PLAN REVIEW SHEET

Petition: 2013-060

Shelter Pad Details

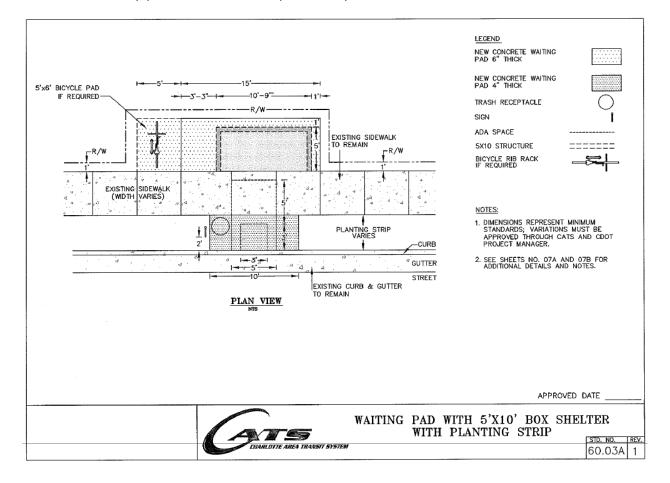
The Petitioner is requested to provide a shelter pad for bus service along Steelecroft Parkway. The conditional plan may either include a development note to locate the shelter pad during the permitting process or show the conceptual location on the site plan. CATS will be responsible for adding the shelter structure to the concrete pad.

The shelter pad is to be located back of the sidewalk within public right-of-way or easement. Between the sidewalk and curb, a connecting access pad must be flush with the sidewalk and level within 2% when measured perpendicular to the street for compliance with the Americans with Disabilities Act (ADA). Below is an image of the standard detail (60.03A) for the requested shelter and access pads. The bicycle pad shown in the below detail may be excluded.
